APPLICATION FOR PERMIT TO DRILL				5. MINERAL LEASE NO: ML-21330	6. SURFACE: State
1A. TYPE OF WORK: DRILL <input checked="" type="checkbox"/> REENTER <input type="checkbox"/> DEEPEN <input type="checkbox"/>				7. IF INDIAN, ALLOTTEE OR TRIBE NAME:

2. NAME OF OPERATOR: KERR MCGEE OIL & GAS ONSHORE L.P.				9. WELL NAME and NUMBER: NBU 1021-29F	
3. ADDRESS OF OPERATOR: 1368 S 1200 E CITY VERNAL STATE UT ZIP 84078			PHONE NUMBER: (435) 781-7024	10. FIELD AND POOL, OR WILDCAT: NATURAL BUTTES

NBU 1021-29F
SE/NW SEC. 29, T10S, R21E
UINTAH COUNTY, UTAH
ML-21330

APPROXIMATE TOTAL PIPELINE DISTANCE = 880' +/-

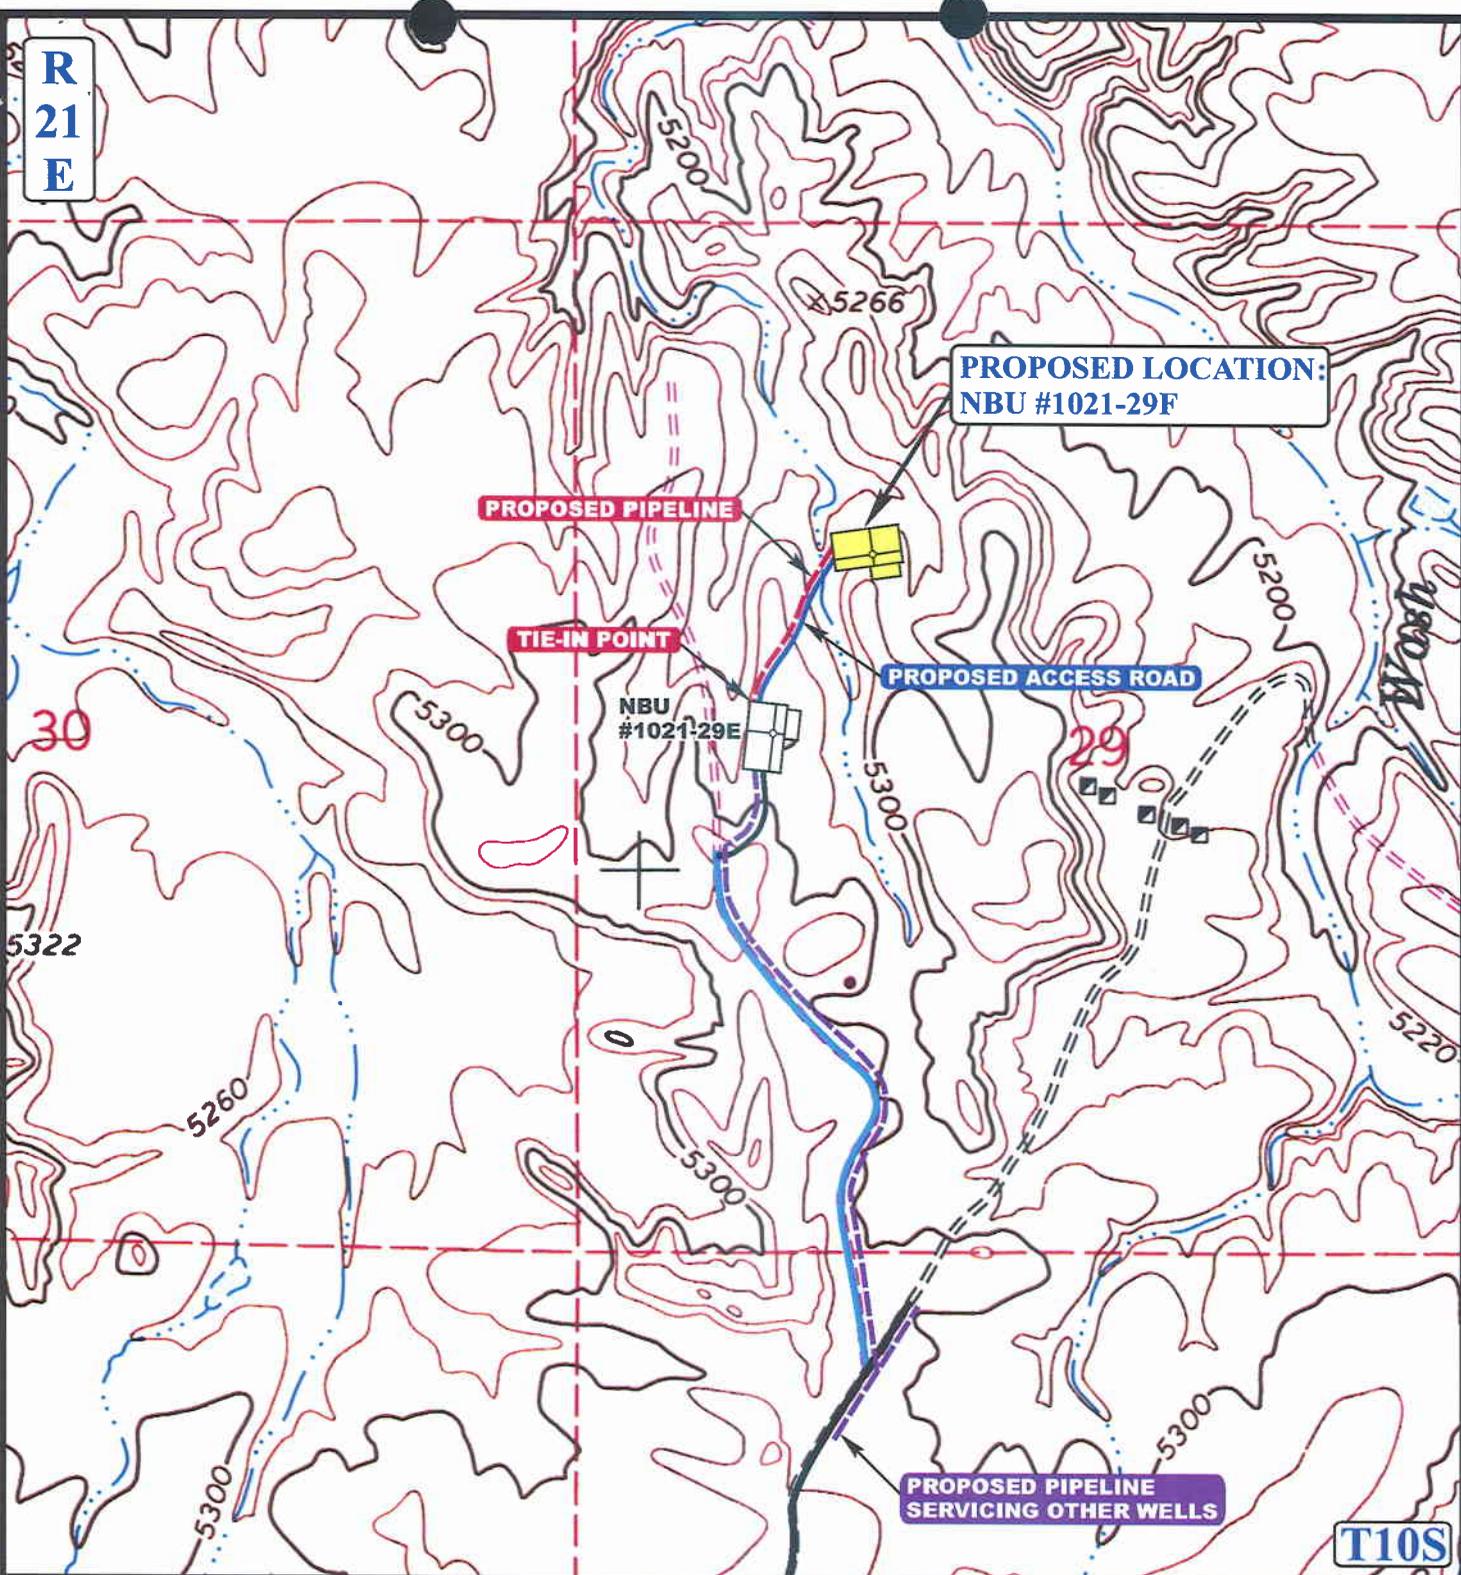
AN ON-SITE INSPECTION WAS CONDUCTED ON 02/13/2007 WITH UDOGM AND SITLA REPRESENTATIVES. IT WAS DECIDED AT THE ON-SITE INSPECTION TO CHANGE THE PROPOSED PIPELINE FROM 880' +/- OF 4" STEEL PIPELINE TO APPROXIMATELY 2300' +/- OF 4" STEEL PIPELINE.

APPROXIMATE TOTAL PIPELINE DISTANCE = 2,300' +/-

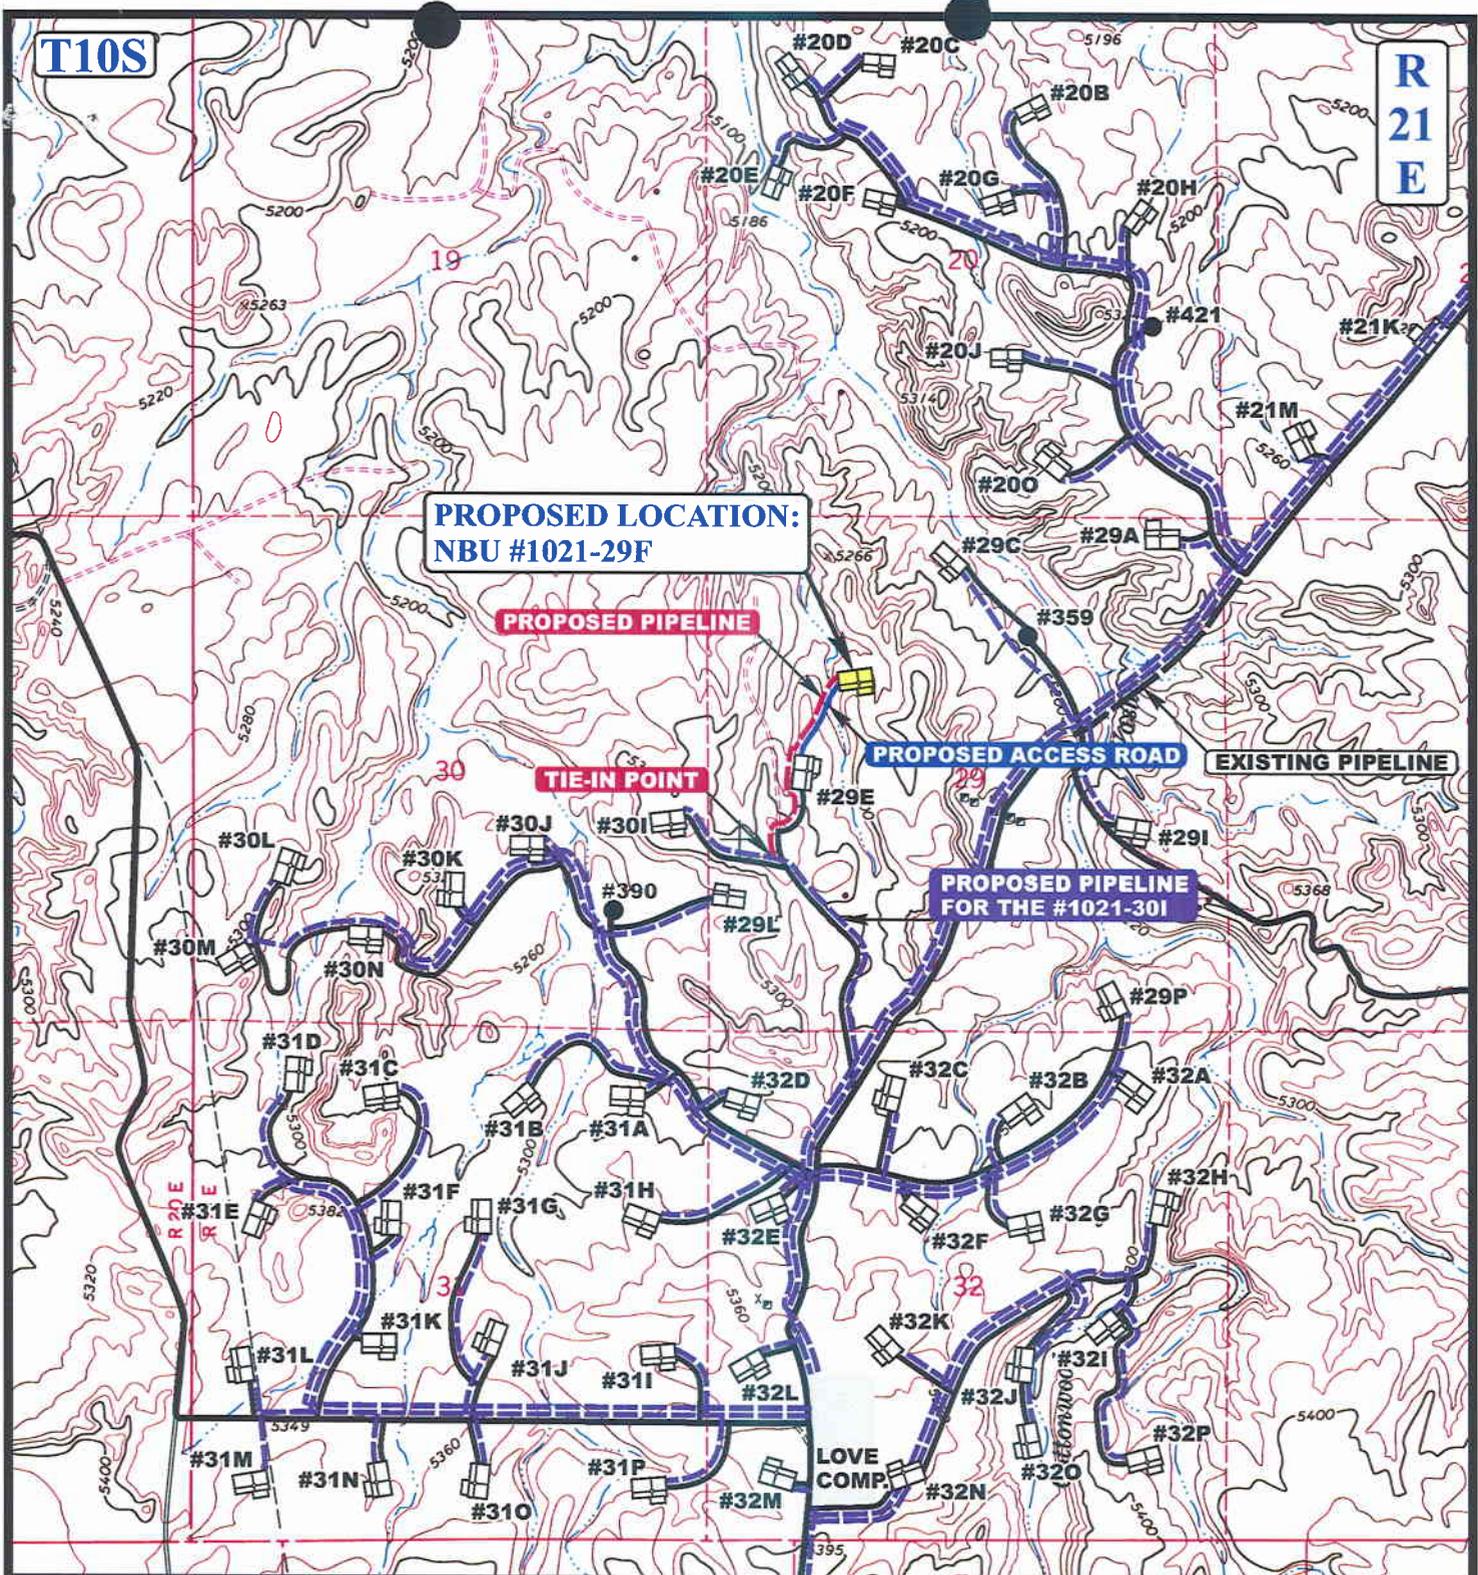
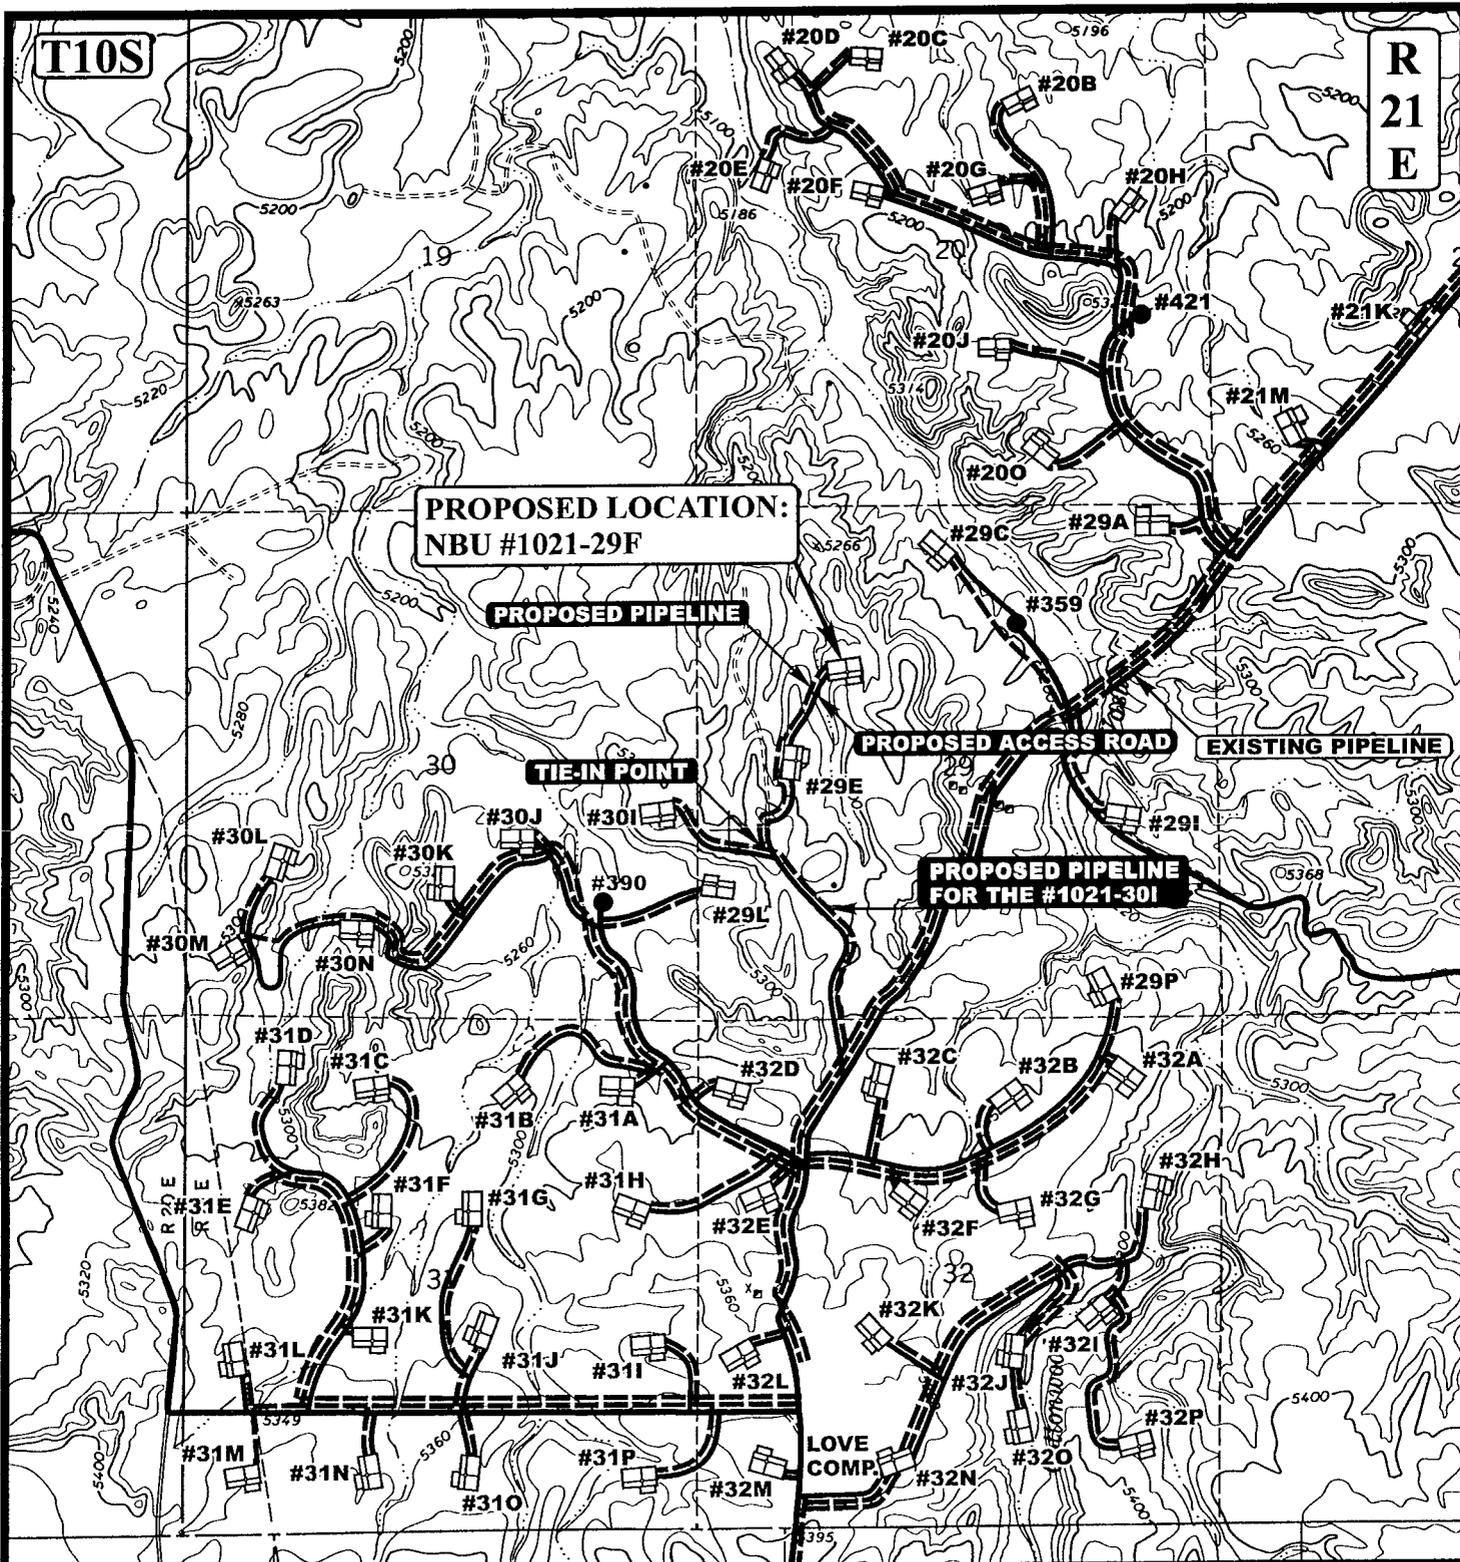
PLEASE REFER TO THE ATTACHED REVISED TOPO MAP D FOR PIPELINE PLACEMENT.
